December 3, 2018

Re: Review of Aquifer Impact Assessment for Circle X Ranch Permit Application – Three (3)
Proposed Simsboro Wells, Robertson County, Texas

Figure 1 - Location Map

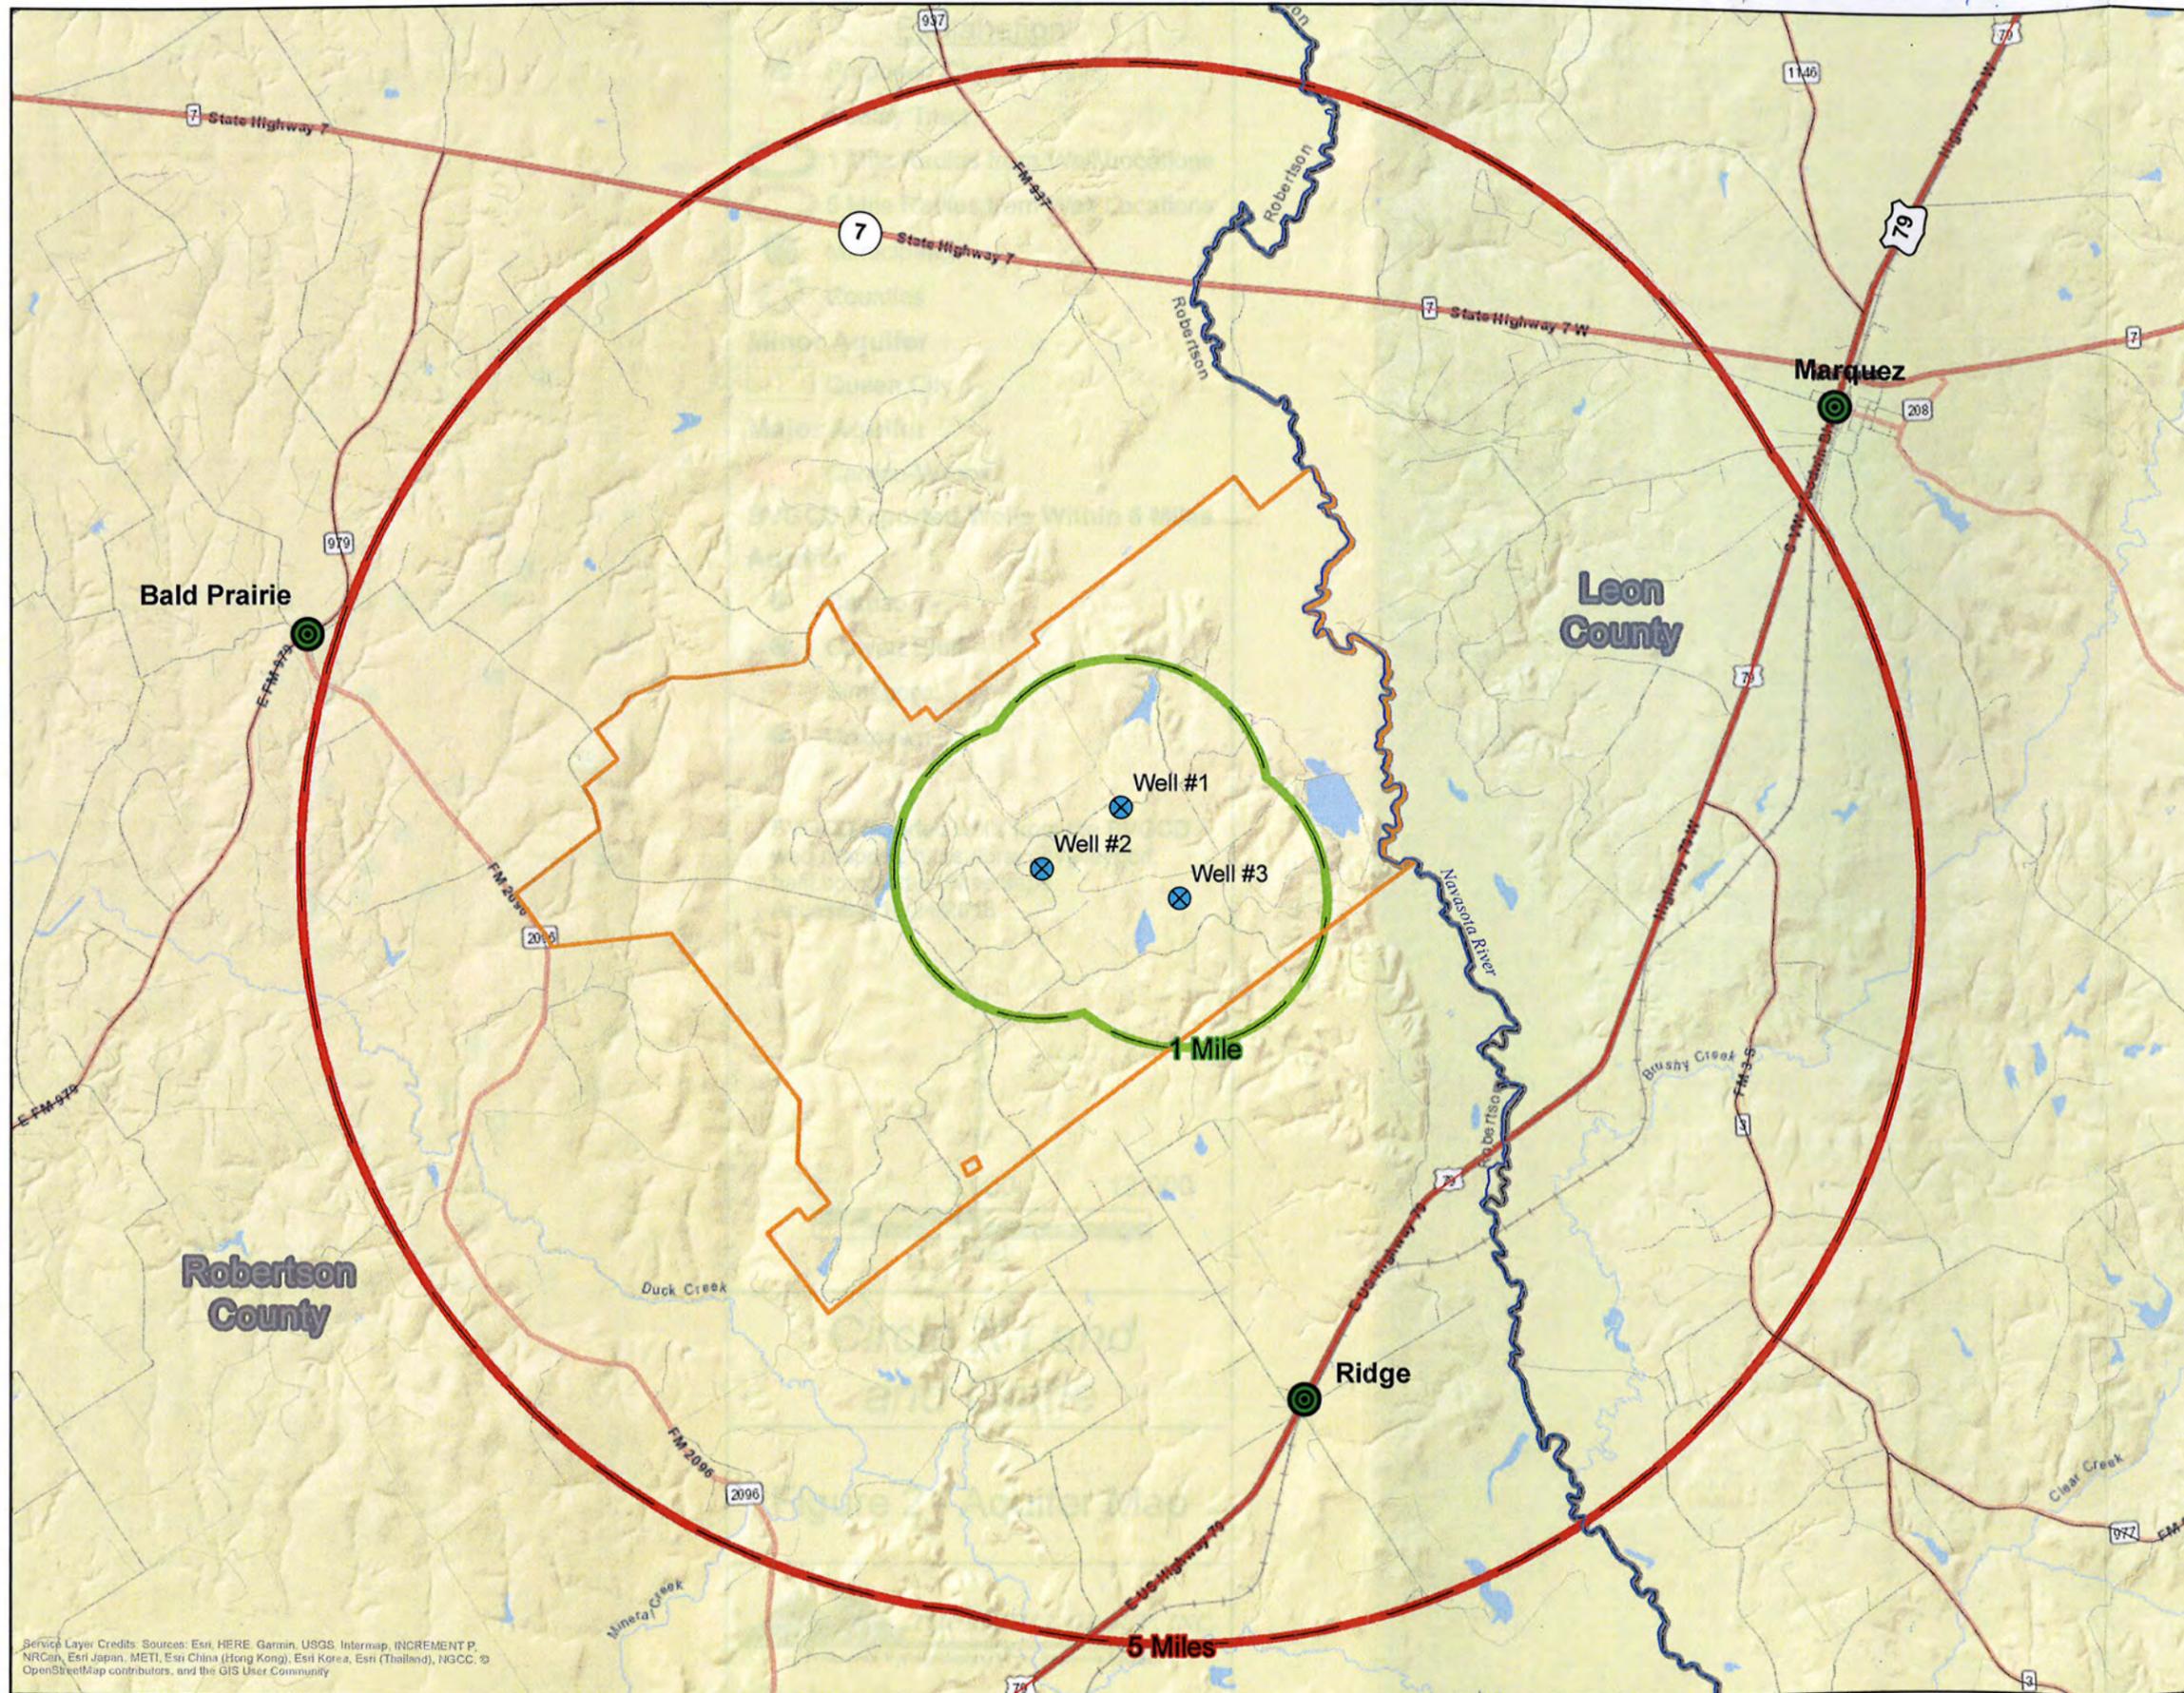
The permit application for the three wells is for an overall withdrawal amount of 9,678 ac-ft/yr, which is equivalent to an average pumping rate of 6,000 gallons per minute (gpm) continuously for one year. The proposed locations for the wells are shown on the attached figure, which was provided as part of the hydrogeological evaluation report.

Figure 5b - Well Locations Within 1 Mile of Proposed Circle X Wells

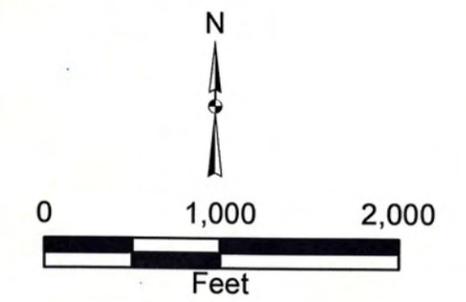
2. As required by the Rule 8.4(b)(7)(B)(2), a table is provided regarding water wells that are located within one mile of the proposed well locations. There are two registered wells that occur within the one-mile radius area. One well listed, BVR-0484, is located about 3,000 feet northeast of

proposed Simsboro Production Well No. 3. The well is listed in the BVGCD database as screening sands of the Simsboro Aquifer. With the well having a reported total depth of 300 feet, the well would actually screen sands of the Calvert Bluff Aquifer. The aquifer designation has been corrected for the well. A map showing the locations of the wells also is included.
